RESOLUTION NO. 2991

A RESOLUTION OF THE CITY OF WILSONVILLE AUTHORIZING THE CITY MANAGER TO EXECUTE THE SECOND AMENDMENT TO CONSTRUCTION CONTRACT WITH MOORE EXCAVATION, INC. FOR THE 5TH STREET / KINSMAN ROAD EXTENSION PROJECT.

**CITY OF WILSONVILLE
SECOND AMENDMENT TO CONSTRUCTION CONTRACT**

5th Street/Kinsman Road Extension

Pay Item 2003: Bridge Wing Wall Fence

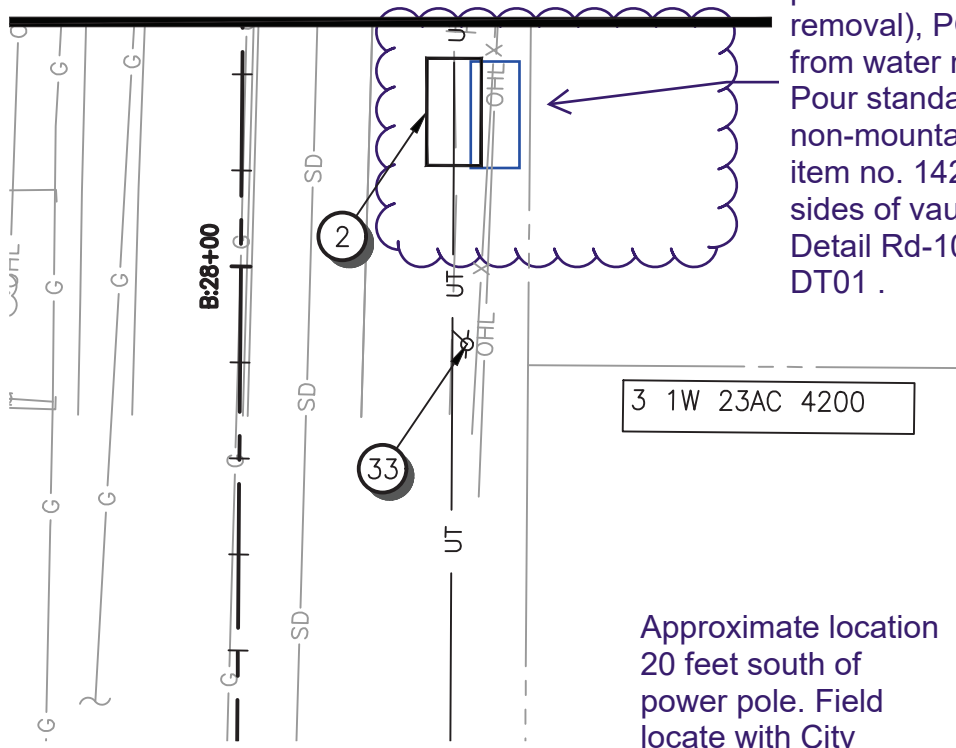
Contractor raised a safety concern with the design engineer regarding a potential fall hazard where the sidewalk is adjacent to the bridge wing wall. There is an elevation difference of up to 4 feet between the top of the bridge wing wall and the adjacent Coffee Lake Creek with no barrier provided between the sidewalk and bridge wing wall. The City and design engineer agreed with the Contractor's safety concern and proposes installation of a 4-foot high, black, vinyl coated, chain link fence for each wing wall on both the 5th Street Bridge and Kinsman Road Bridge as documented in RFI 080 (p. 29-32 of Exhibit C).

Contractor provided timely notification to the City that the added bridge wing wall fence results in added costs as documented by Change Order Request #021 (p. 33-35 – Exhibit C) and the City has determined that the work is an acceptable reimbursable project expense.

The Bridge Wing Wall Fence pay item shall include all costs for materials, equipment, and labor to construct the fencing as directed in RFI 080 (p. 29-32 of Exhibit C) and Section 01050 of the 2018 Oregon Standard Specifications for Construction. This pay item will not be measured in the field and will be paid on a lump sum basis at the Contract price.

Add Standard Curb to PGE Vault 221

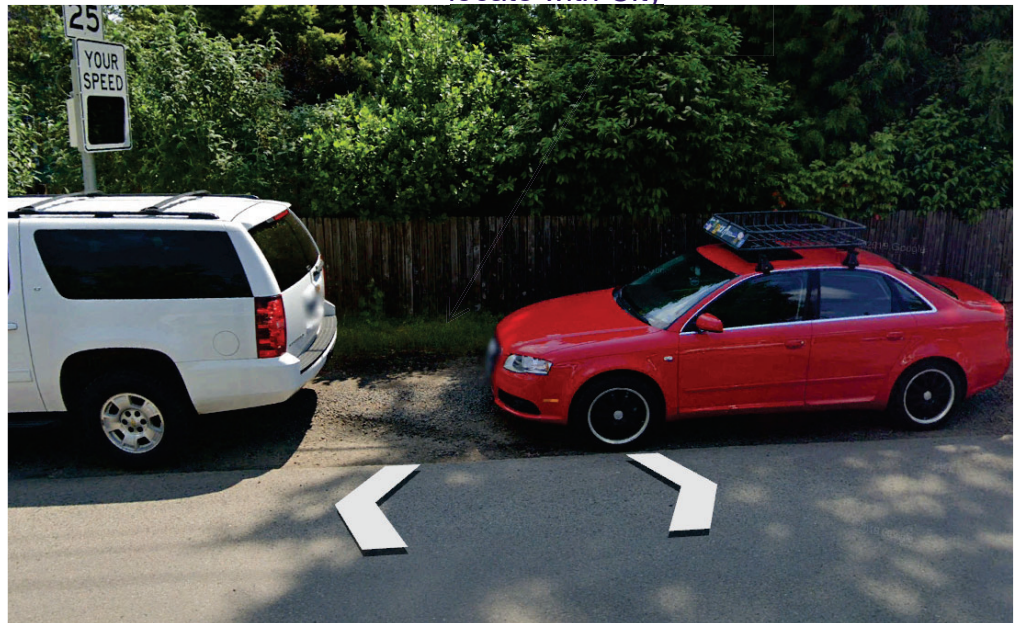
Add Standard Curb to PGE Vault 221 – During construction of the underground electrical infrastructure, PGE requested standard curb be installed along the outside edge of electrical vaults located within parking areas. PGE Vault 221 is located along an unimproved portion of Boones Ferry Road, south of 5th Street within an existing gravel area adjacent to the paved roadway. PGE vault lids are not structurally rated for traffic loading. As a result, PGE has requested standard curb be installed along the south, west, and north edges of PGE Vault 221 to prevent vehicles from driving over or parking on top of the vault lid. The design change is included on page 4 of Exhibit C. This design change results in increased estimated quantity of Pay Item 142 – Non-Mountable Median - Asphalt Streets.

Approximate location for vault 221.
Field adjust based on fence post locations (minimal removal), PGE clearances (2' from water main)
Pour standard 6" non-mountable median (bid item no. 142) around front and sides of vault to protect it - See Detail Rd-1065 on Sheet 122, DT01 .

Approximate location 20 feet south of power pole. Field locate with City

Pay Item 2002: Concrete Water Quality Curb Removal

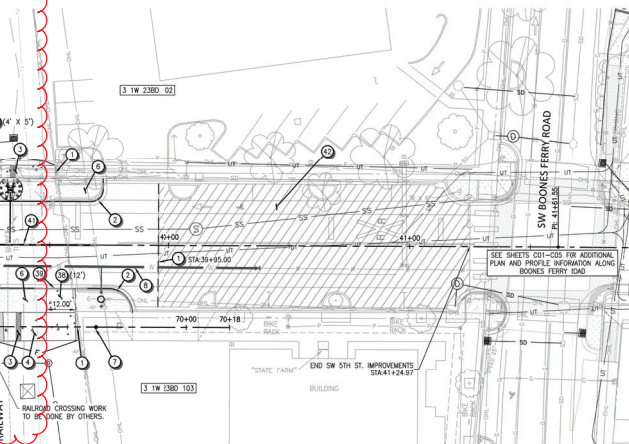
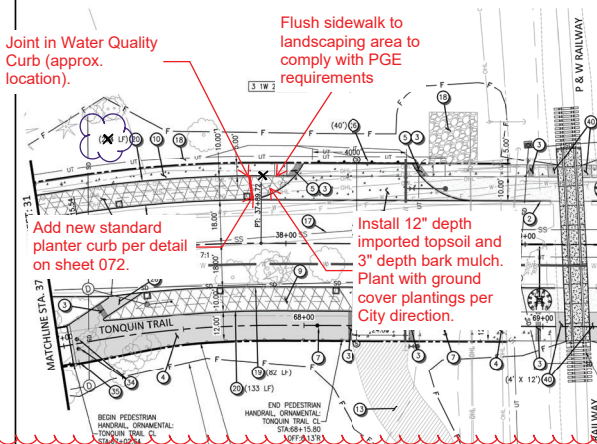
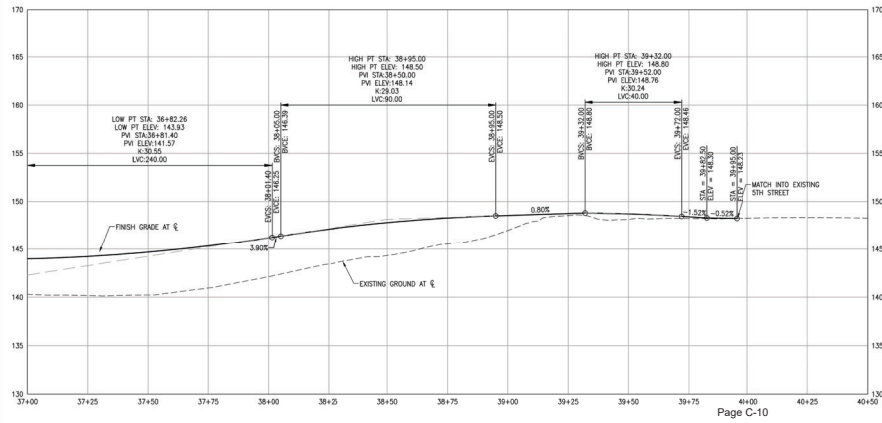
Modify Water Quality Facility for PGE Vault 68 – During construction of the underground electrical infrastructure, PGE requested that the water quality facility located south of PGE Vault 68 be replaced with a standard landscape strip to provide PGE required 10 feet worker safety clearance. The design engineer reviewed the request and confirmed the design change can be accommodated and is documented per Change Order Request #018 (p. 8-11 – Exhibit C). The design change results in a net decreased estimated quantity of Pay Item 148 – Concrete Water Quality Curb and increased estimated quantity of Pay item 141 – Non-Mountable Median - Concrete Street. It is assumed that the difference between backfill, excavation, soil, plantings and all other work not specifically identified in this Change Order No. 2 for the conversion of the water quality swale and the landscape planter strip is negligible for which no separate or additional measurement or payment will be made.

Prior to modification of the water quality facility for PGE Vault 68 as described above, a 12-foot long section of water quality curb had already been installed to the south of the vault. To accommodate the

conversion of the water quality facility to a standard landscape strip, this section of water quality curb needs to be removed.

REMOVE 12-FT SECTION OF CURB IN FRONT OF 612 PGE VAULT; POUR BACK STANDARD CURB; REQUIRED PER PGE SPEC FOR ACESS TO VAULT (SHEET UT10)

Contractor provided timely notification to the City that the removal of the water quality curb results in added costs as documented by Change Order Request #018 (p. 8-11 – Exhibit C) and the City has determined that the work is an acceptable reimbursable project expense.

The Concrete Water Quality Curb Removal pay item shall include all cost for materials, equipment, and labor to remove and dispose of the identified section of water quality curb. This pay item will not be measured in the field and will be paid on a lump sum basis at the Contract price.

**SW 5TH ST TO SW KINSMAN RD EXTENSION
 5TH ST PLAN & PROFILE - ROADWAY
 PLAN AND PROFILE**

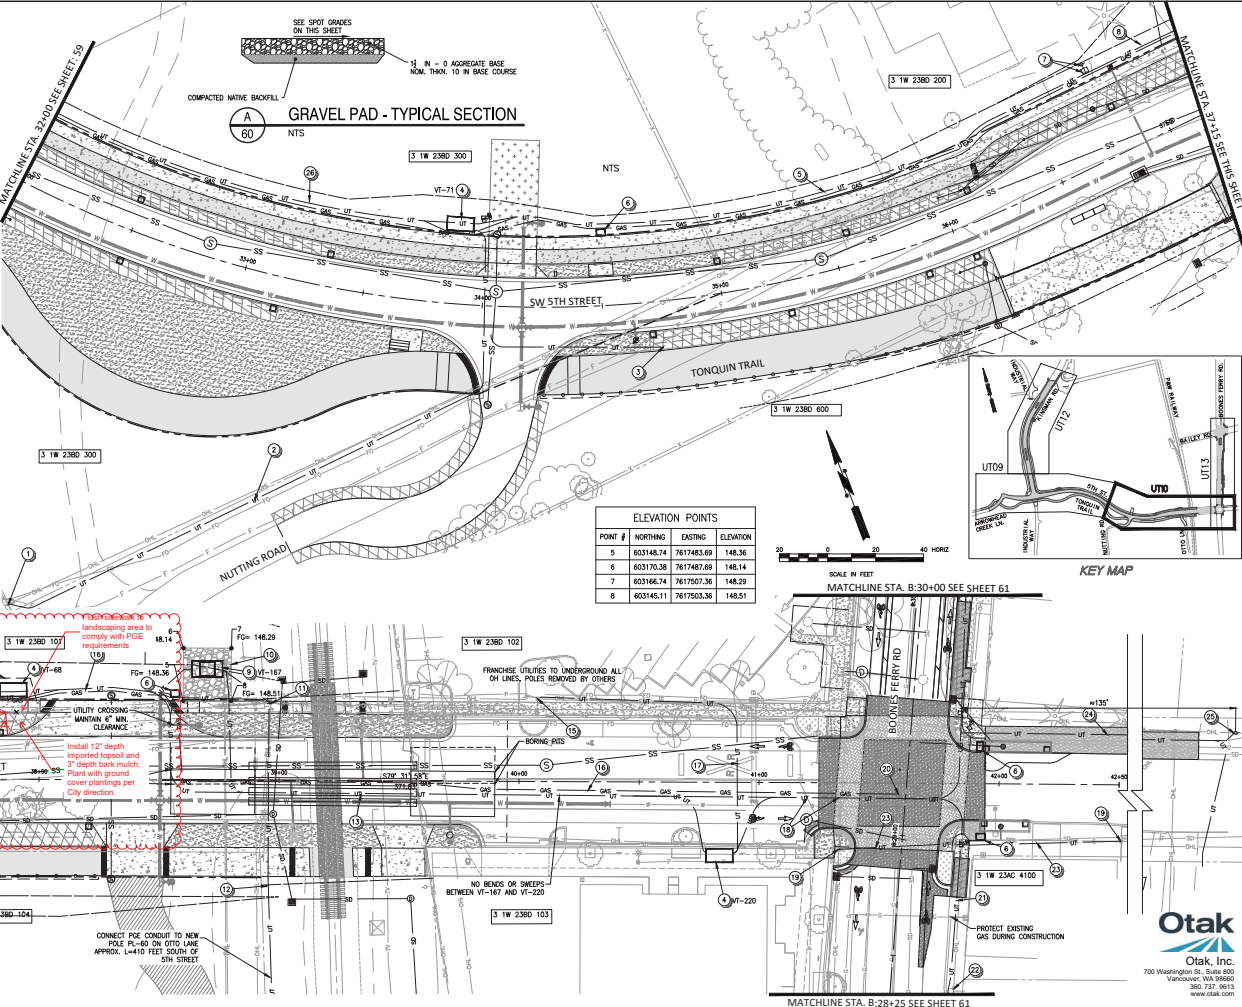
- 29 landscaping area to comply with PGE requirements
- 30 Joint in Water Quality curb (spec. location)
- 31 Add new standard number curb per detail on sheet 07.2

- 32 Install 12" depth imported topsoil and 3" depth bark mulch. Plant with ground cover plantings per City direction
- 33 CONNECT PGE CONDUIT TO NEW POLE PL-60 ON OTTO LANE APPROX. 1-1/2 FEET SOUTH OF 5TH STREET

Railroad Utility Crossing Casing Design Modifications

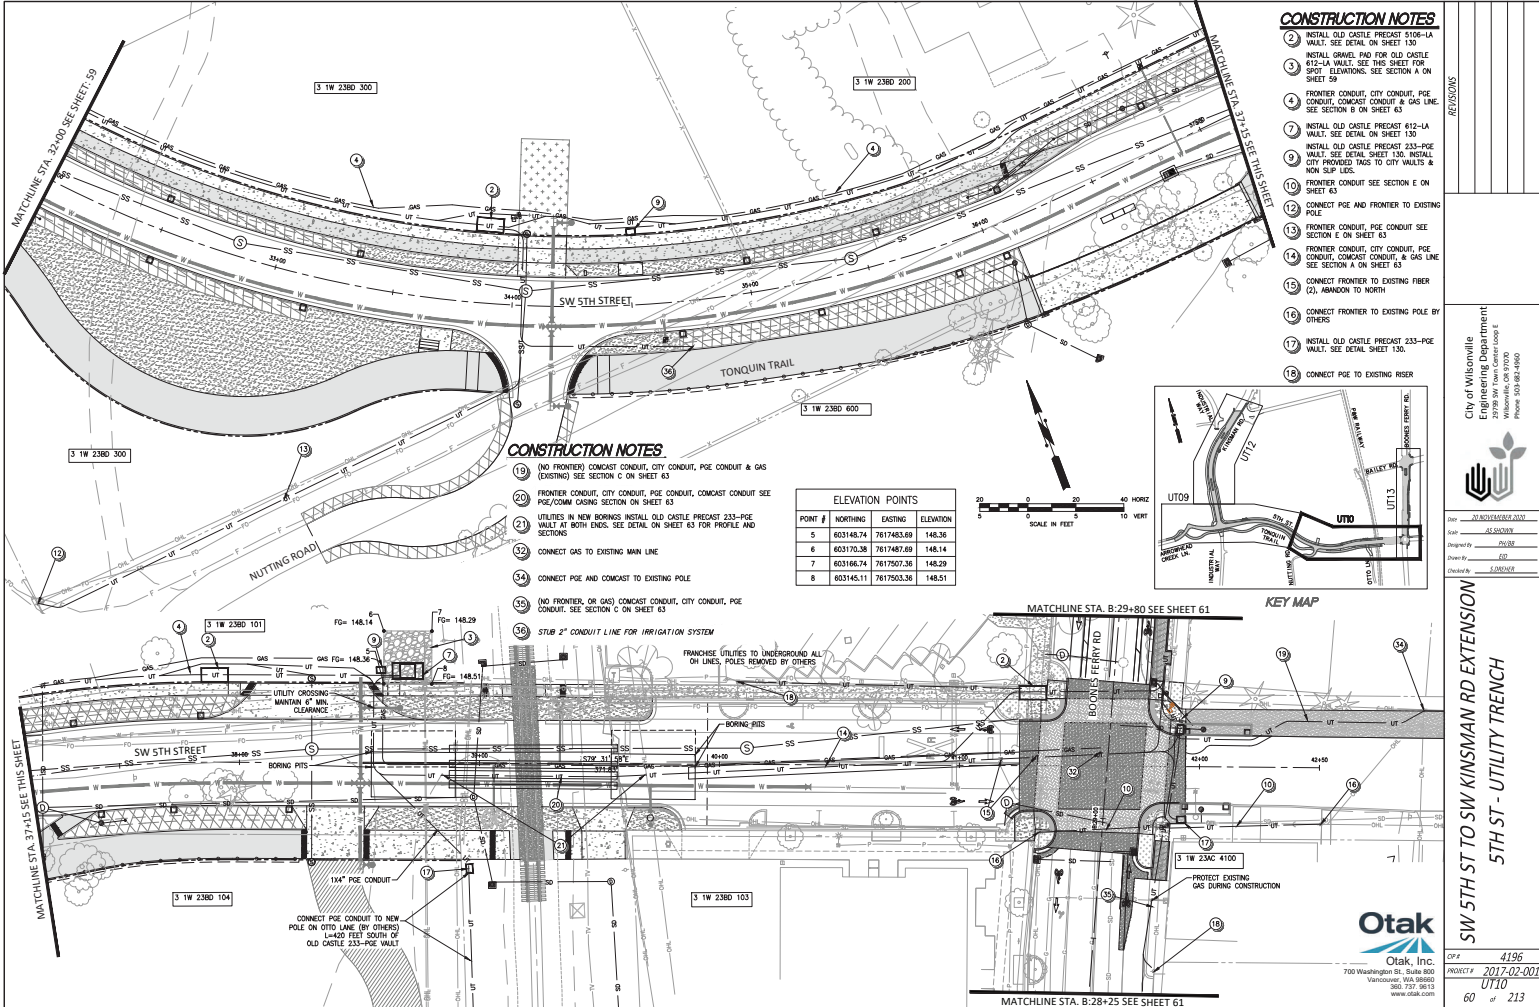
During bore installation of the 6” diameter casing pipe for the natural gas pipeline crossing beneath the railroad tracks, the Contractor was unable to complete the work after a number of attempts due to the presence of boulders. The Contractor determined that the small size of the casing pipe does not provide enough room to access and remove the conflicting portions of boulders. The Contractor proposes an upsized 36” diameter casing pipe to provide the needed space to remove conflicting boulders and complete installation of the needed casing pipe. In addition, the Contractor mistakenly installed a larger, 36” casing for the City water pipeline, rather than the 18” casing called for in the construction documents. The utility casing pipe design changes for the railroad crossing are included on pages 23-24 of Exhibit C.

Item	Description	Qty	Unit	Unit Price	Extension
Description of Change(s)					
Boulders were encountered while installing the 6" gas casing at the design depth of 7' ; This was not called out in the plans or geotech report and is a differing site condition; this COR reflects the standby time as a result, and the costs to upsize the casing to alleviate the boulder issue.					
Pricing					
Reject	Standby time	1.00	LS	\$ 17,118.04	\$ 17,118.04
Reject	Additional Work Upsize 6" Gas Casing to 36"	1.00	LS	\$ 17,824.20	\$ 17,824.20
Approve	CREDIT BI 55 6" Casing 7 FT Depth	1.00	LS	\$ (40,000.00)	\$ (40,000.00)
Approve	BI 57 36" Casing 7 FT Depth	1.00	LS	\$ 80,000.00	\$ 80,000.00
Reject	Bore Sub Additional DeMob and Mob	1.00	LS	\$ 12,800.00	\$ 12,800.00
Approve	City Share Gas Casing Relocation Work				\$20,000.00
	TOTAL				\$ 60,000.00
Terms, Conditions, and Scope Limits/Clarifications					
Additional contract days will be requested starting from the beginning of the delay on 10/18/2021 to the end of the delay when pricing is approved

Note: The City does not agree that the obstructions encountered constitute a differing site condition, but agrees to pay a portion of added work to install a larger casing for the gas line.

1. RR Crossing unforeseen change request. The City will accept the last settlement offer of paying the difference between the 6" casing and the 36" casing for the Gas casing (\$40,000) as well as paying 0.5 of the 6" bid item for all other extra work claimed (\$20,000).
2. Water Quality Curb reinforcing credit. The City will accept the last credit amount of \$7,000.00.

SW 5TH ST TO SW KINSMAN RD EXTENSION
 COFFEE LAKE CREEK (5TH ST) BRIDGE
 PLAN AND ELEVATION

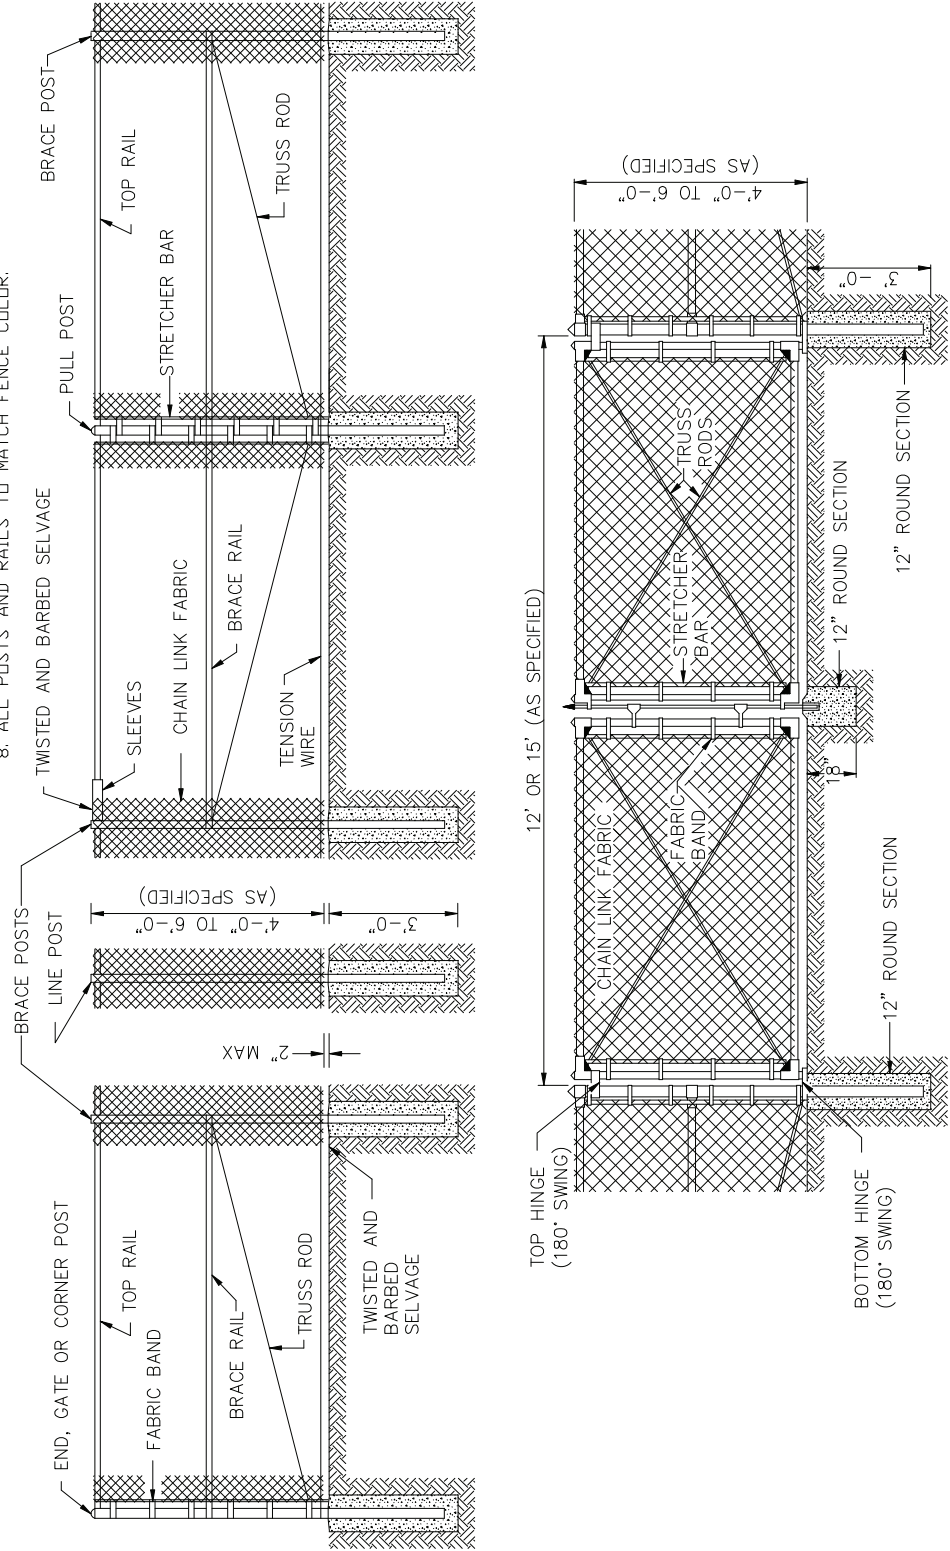
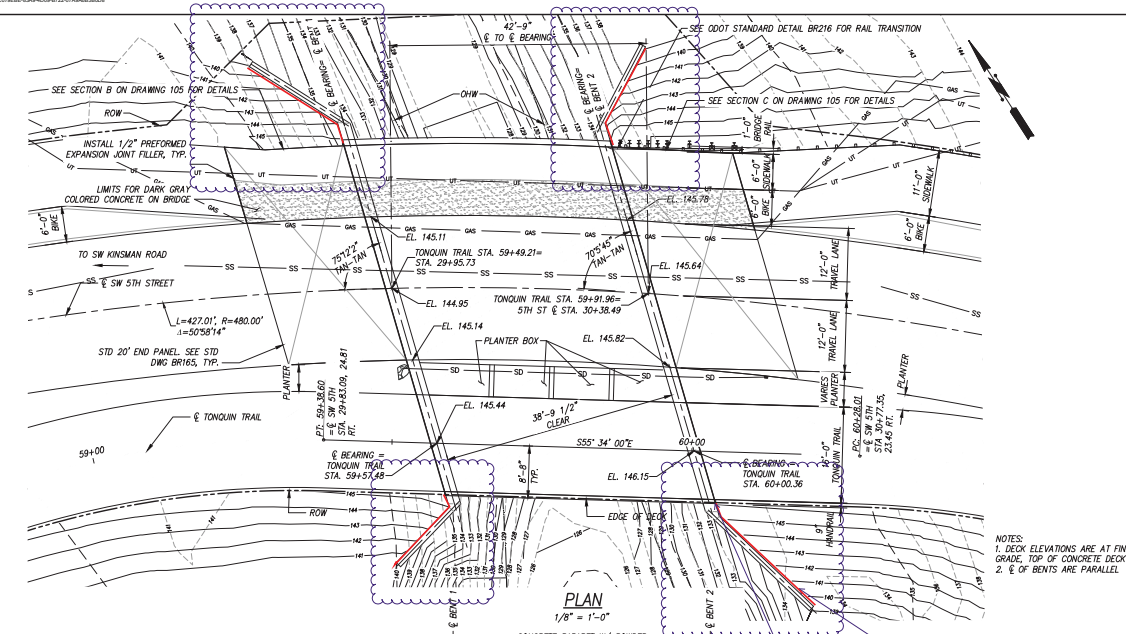
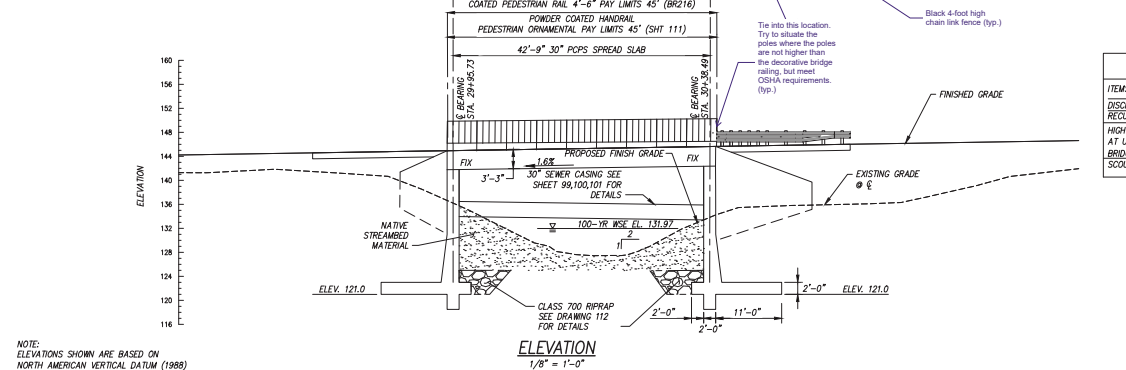
Sheet PP-03 Note 25 calls for a 31" height guard rail.

The city would like to add chain link fence. Please provide a proposal for installing 4-foot high black chain link fence (CWS standard detail No. 792) for each bridge. The fence locations would be from the corner for the bridge railing along the back side of the wing walls at all four corners. Please follow OSHA standards and requirements. The tops of the poles should be situated as best as possible below the decorative bridge deck railing. Confirm field location and fit with city inspector prior to placing.

Per RFI 080 response MEI was directed to install chainlink fence at the 5th Street & Kinsman Rd bridges; This COR reflects the cost to install.
